SUNDRY NOTICES AND REPORTS ON WELLS
Do not use this form for proposals to drill or to re-enter an abandoned well. Use form 3160-3 (APD) for such proposals.

8. Well Name and No.
GISSLER B 27

EOG Resources, Inc. plans to plug and abandon this well as follows:

Permanent Abandonment of Federal Wells
Conditions of Approval (LPC Habitat)

Gissler B (A2) #27

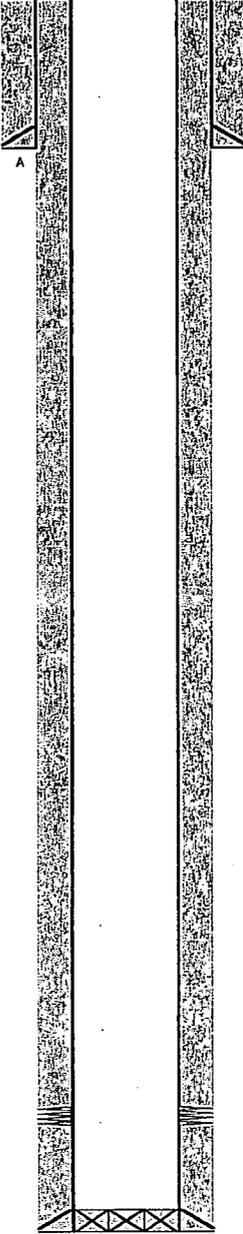
**** BLM REVISED ** BLM REVISED ** BLM REVISED ** BLM REVISED ** BLM REVISED ****

COMMENTS
